ARTICLE 800 — COMMUNICATIONS CIRCUITS

16-347 Log #35 NEC-P16 **Final Action: Accept in Principle**
(800.1)

Figure 820.154
Cable
Substitution
Hierarchy

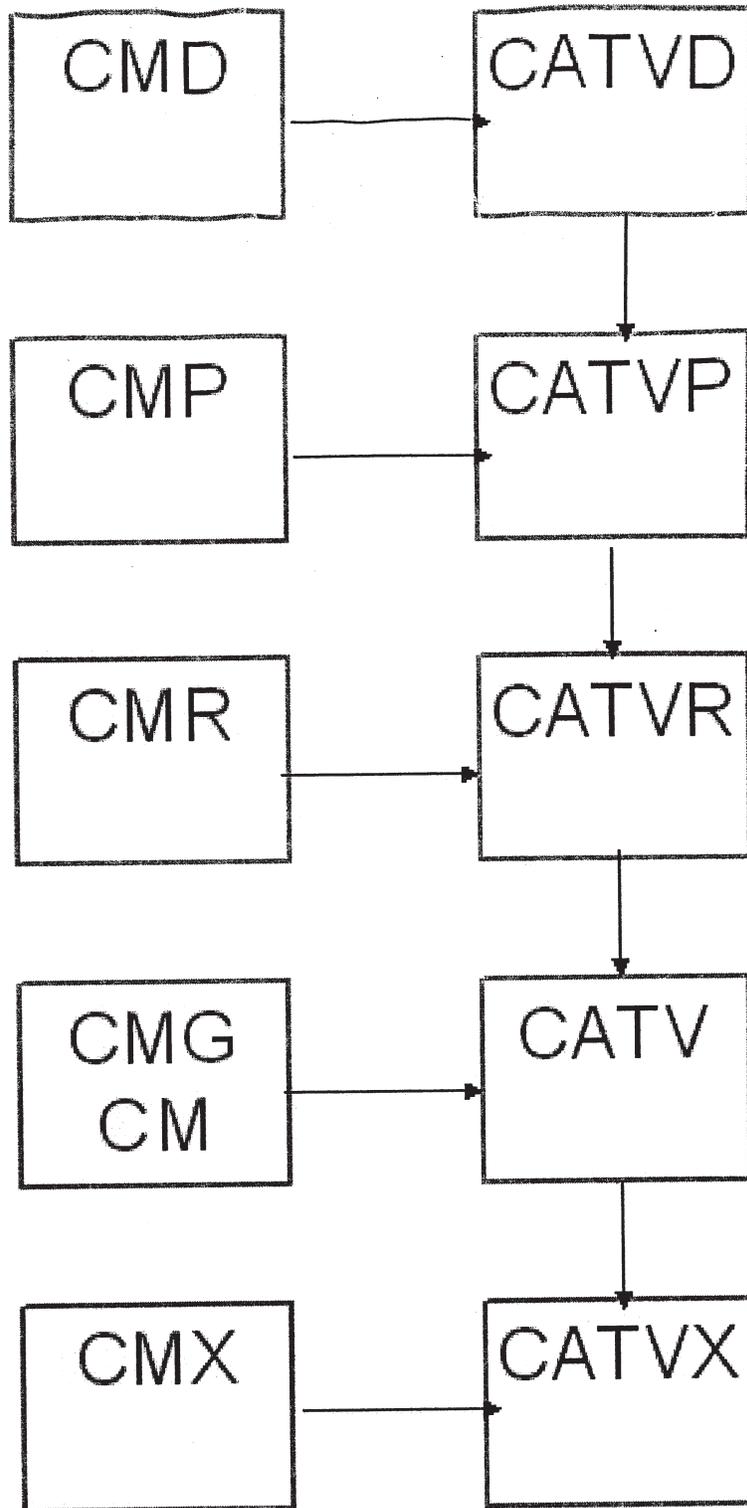
Note: See Figure 820.61. Cable Substitution hierarchy.
